ARCTIC NATIONAL WILDLIFE REFUGE, ALASKA, COASTAL PLAIN RESOURCE ASSESSMENT

**REPORT AND RECOMMENDATION TO THE CONGRESS OF THE UNITED STATES
AND FINAL LEGISLATIVE ENVIRONMENTAL IMPACT STATEMENT**

APPENDIX--PUBLIC COMMENTS AND RESPONSES

APRIL 1987

FIGURE 1. Locations of bowhead whales feeding near ANWR. The source of these data are D. Ljungblad surveys conducted for the Minerals Management Service.

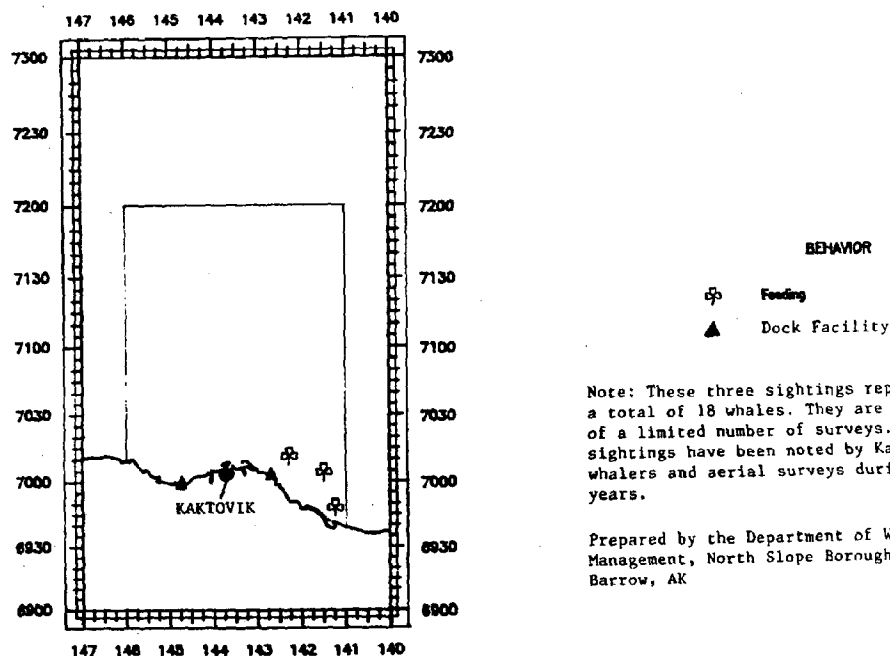
The brief description at p. 119 of the "Impacts" to bowhead whales is inadequate and does not mention that the marine waters off ANWR appear to be a major bowhead feeding area. (See attached Figure 1). This section must also be strengthened to recognize that noise disturbance from one or more port facilities is likely to be much more significant than reactions of individual whales to noise sources reported in other studies. The conclusion (p. 119) that there would only be minor behavioral changes is premature and not supported.

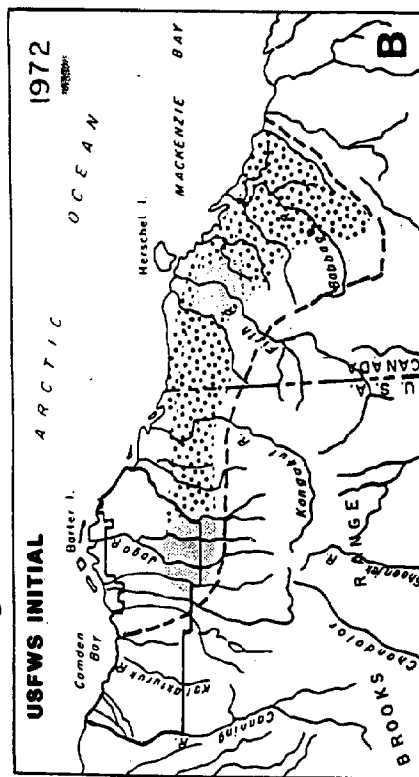
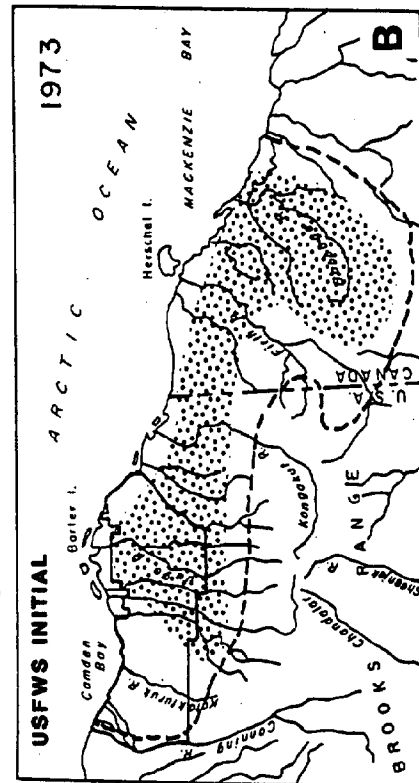
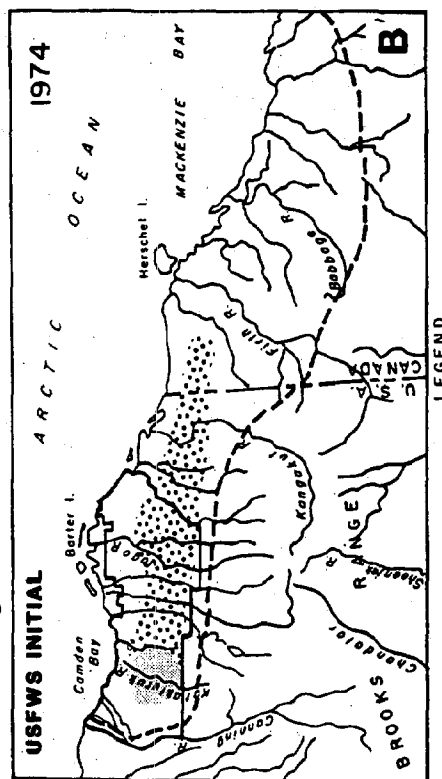
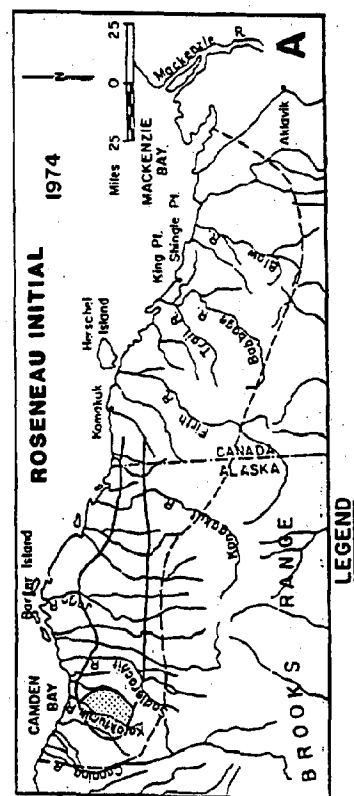
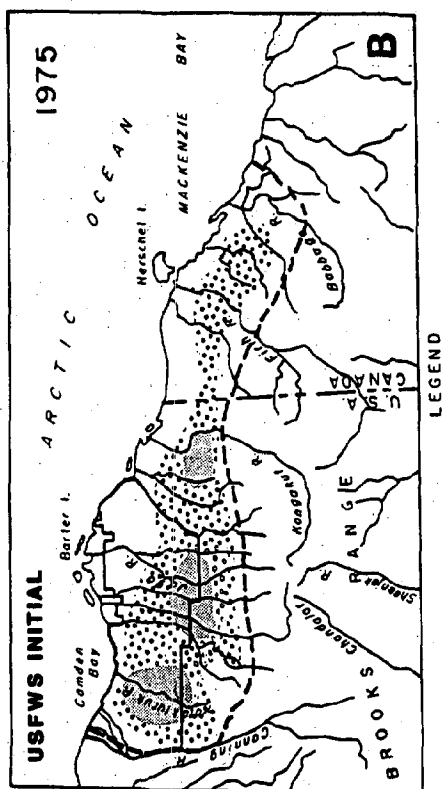
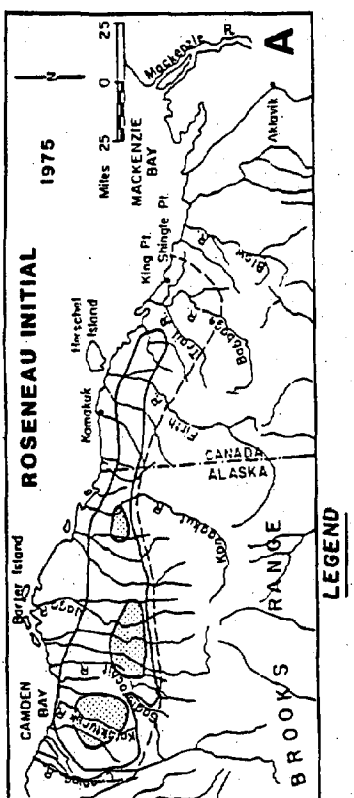
There are serious limitations in the data that were available to plot the location and areal extent of concentrated calving areas, particularly for 1972-1981 (Plate 2A). Maps of calving concentrations observed in those years (Fig. 3) were prepared by D. G. Roseneau (1987, pers. comm.) to show variability in calving area locations and were never intended to be used for precise mapping of calving concentrations. The original map scale (1 inch = 50 miles) is far too small to have permitted the data to be replotted accurately to a larger scale map. [Unfortunately, much of the original data was lost in an office fire, and thus more detailed information about the location of the calving concentration areas is not available.]

Several problems have been identified with the maps of FCH calving concentration areas shown in Plate 2A. In addition to relatively small plotting errors that can be expected, there are substantial errors that have caused mapped calving areas to become larger in size, to change shape, and to "migrate" (about 16 miles in one case for 1977) (Fig. 3).

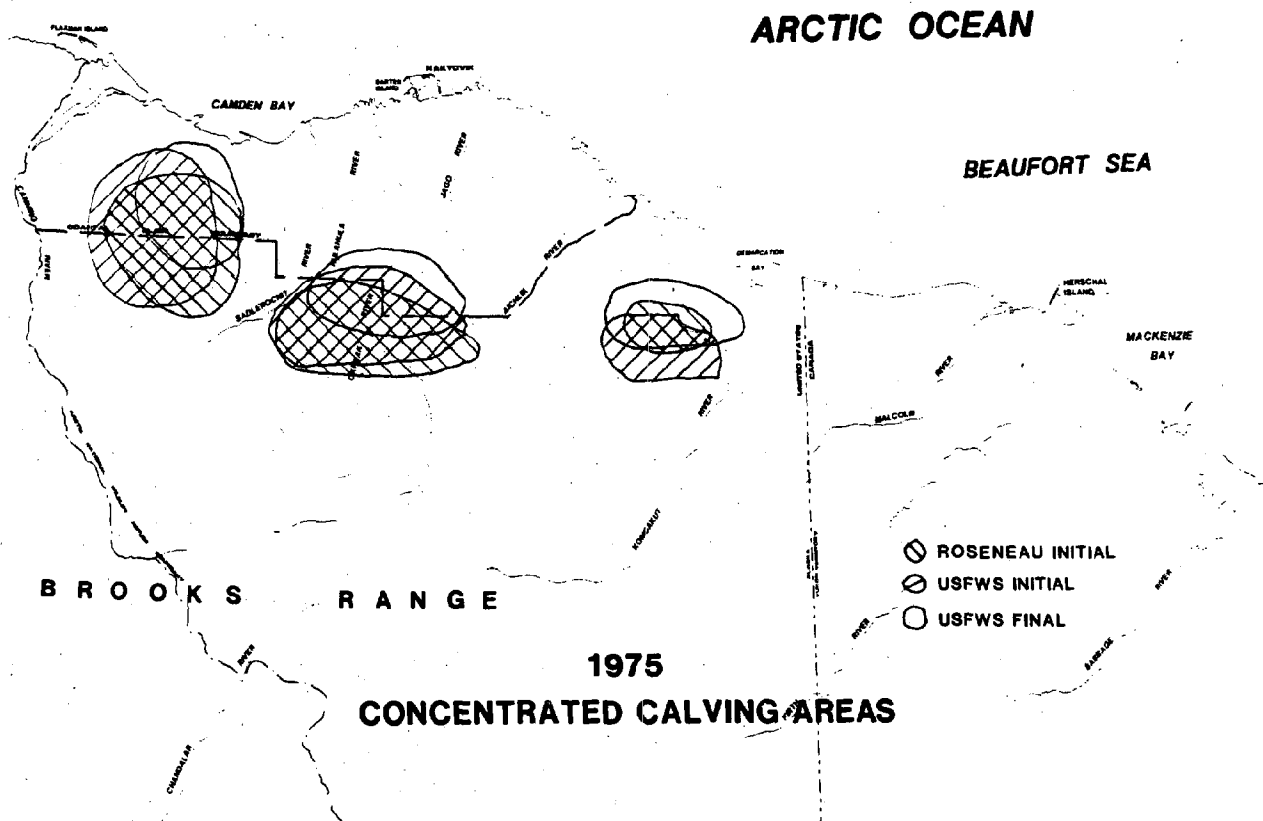
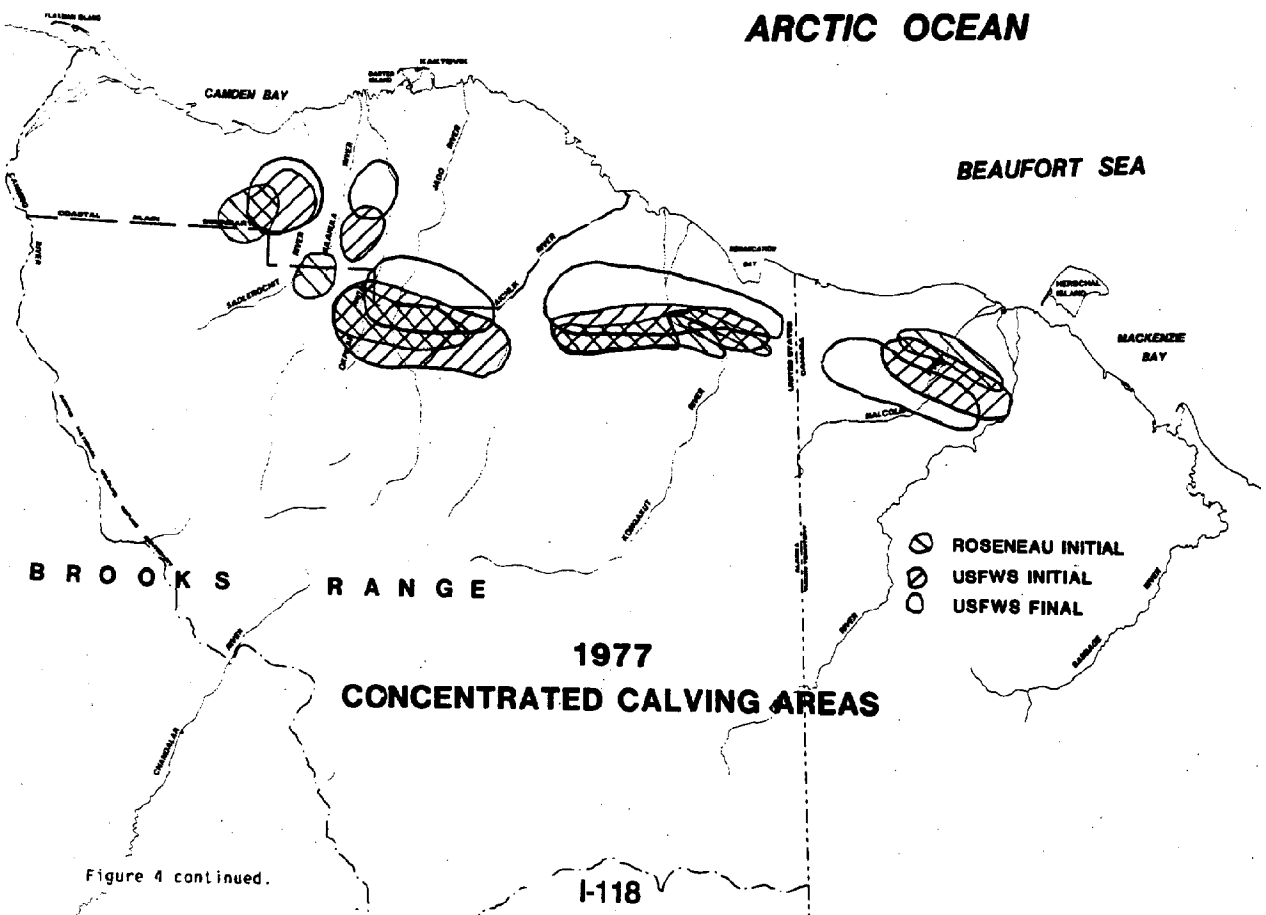
The years 1975, 1976, and 1977 will serve to indicate the magnitude of the alterations that have crept into the draft report's analysis of locations of PCR calving concentration areas. Figure 4 shows three different representations of the same information: 1) an accurate transfer of data from the original maps (Fig. 3); 2) the version presented in the ANWR Initial Baseline Report (FWS 1982) (Fig. 3); and 3) the version from FWS computer files which formed the basis of Plate 2A in the draft report. It is clear that there are substantial differences between these three versions, and that there are significant problems associated with transferring data from very small-scale maps to larger-scale maps. The larger-scale maps (Plate 2A) cannot responsibly be used for any purpose other than to provide a general indication of areas that have received higher than average use by calving caribou in some years. It is inappropriate to state that these areas accurately represent locations where caribou were present in densities equal to or greater than 50 animals/square mile, or to designate a specific tract formed by composites of such areas as a special resource category with assumed site characteristics that are "unique and irreplaceable on a national basis".

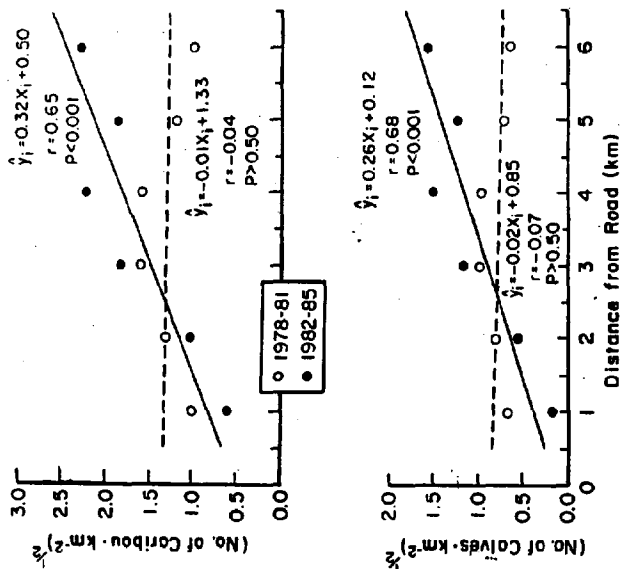
Figure 5 presents graphs from the Dau and Cameron paper showing the relationship between the square root of the density of all caribou and also of calves only, and distance from the road. The data points shown are the means of four years; no information about year-to-year variability is given. The data were collected by helicopter surveys conducted during the four years prior to road construction (1978-1981) and the four years following road construction (1982-1985). The intent, of course, was that the first four years' data would serve as a control against which to compare caribou distribution after the road was in place and development had begun.

Use of the square root transformation and of calculated regression lines (Fig. 5) gives the impression that caribou density was evenly distributed within 6 km of the alignment prior to construction of the road, but afterwards was low near the road and high away from it. If we take the graphs in Fig. 5 at face value, an effect relating to the presence of the road appears to continue out to at least 6 km. However, removing the square root transformation gives quite a different picture (Fig. 6). Examination of the non-transformed data leads to four observations:

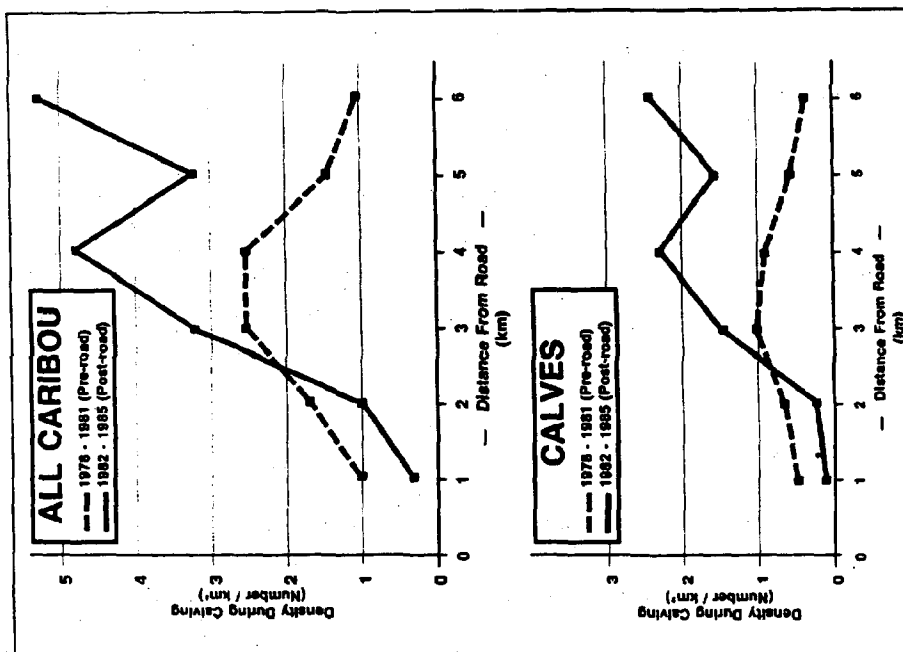
What explains the pattern seen in Figure 6? It is impossible to know. Dau and Cameron's (1985) study is too unclear to permit a conclusion to be drawn, and there is no scientific basis to conclude from their study that any displacement of caribou resulted from the road and associated activity. If the numbers out to 6 km are compared, it is clear that there were about twice as many caribou in the area after the road was constructed than there were
